UNITED STATES PATENT AND TRADEMARK OFFICE

APPLICATION NO.	FILING DATE	FIRST NAMED INVENTOR	ATTORNEY DOCKET NO.	CONFIRMATION NO.
10/810,297	03/26/2004	Luigi Tallone	36030312 US02	9276

Office Action Summary

DETAILED ACTION

FIG. 3I

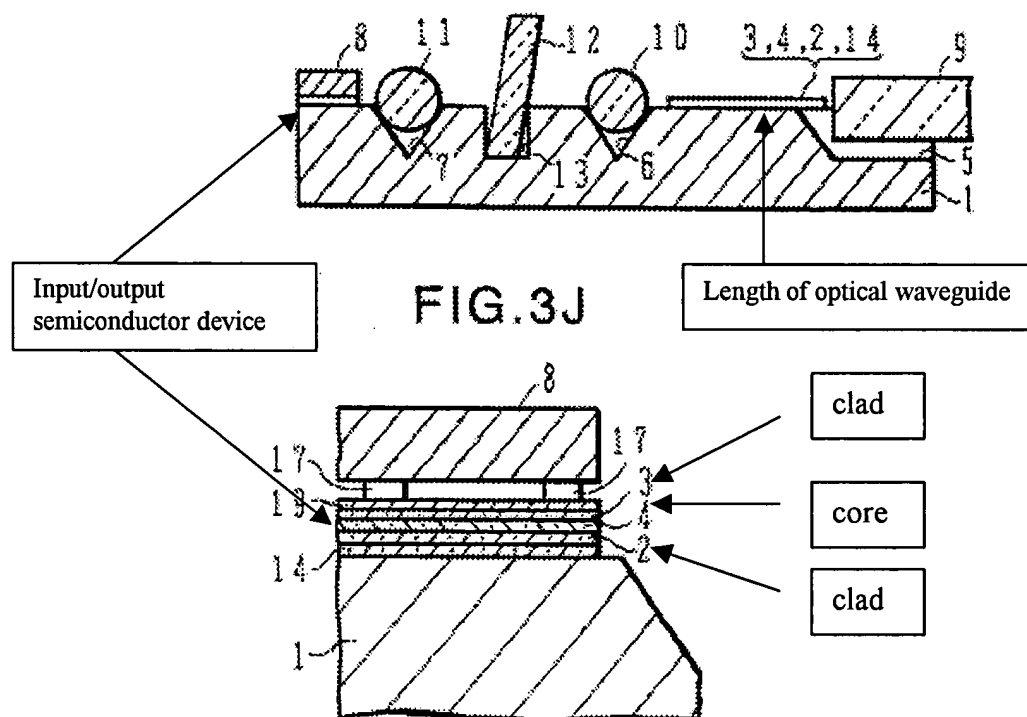
Regarding claims 1 and 15, Tabuchi discloses a mounting arrangement comprising a substrate (1), referring to Fig. 2A, 2B, and 6, an input optical fiber (9) associated with said substrate an output optical waveguide (‘2’ ‘3’ ‘4’) in a given set of planar layers of said output waveguide wherein the output waveguide and the further optical waveguide are aligned along an input-to-output propagation path, thereby providing substantial alignment of said output optical waveguide and said further optical waveguide, said further optical waveguide is interposed between said input optical fiber and said optical component (ball lens 11, isolator 12, or ball lens 10) and wherein said optical component is interposed between said further optical waveguide. Furthermore, Tabuchi teaches an input/output optical semiconductor device (8) further comprising a waveguide (‘2’ ‘3’ ‘4’). Since the core and the claddings of the two segments of waveguides are referred to with the same numeric reference, for differentiating purposes the output waveguide will be referred to as (8) and the length of optical waveguide will be referred to as (14). The length of optical waveguide (14) on said substrate in the same planar layers of

said output optical waveguide (8), the length of optical waveguide is interposed between the input optical fiber (9) and at least one optical component (10, 12, 11) so that at least one optical component is interposed between the length of optical waveguide and the output optical waveguide.

FIG. 2A

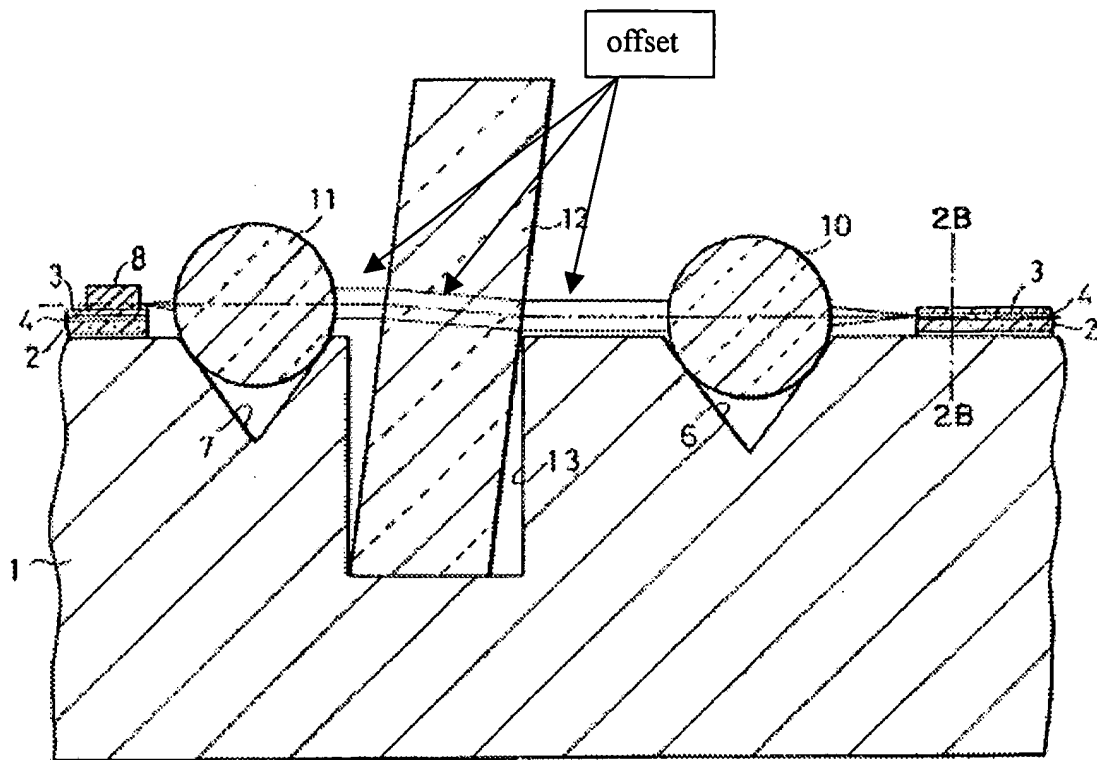
Regarding claim 8 wherein the end surfaces of the output waveguide and the length of optical waveguide are offset to a perpendicular to input-to-output propagation path and a

propagation path of radiation through at least one optical component is at an angle with respect to the input-to-output propagation path.
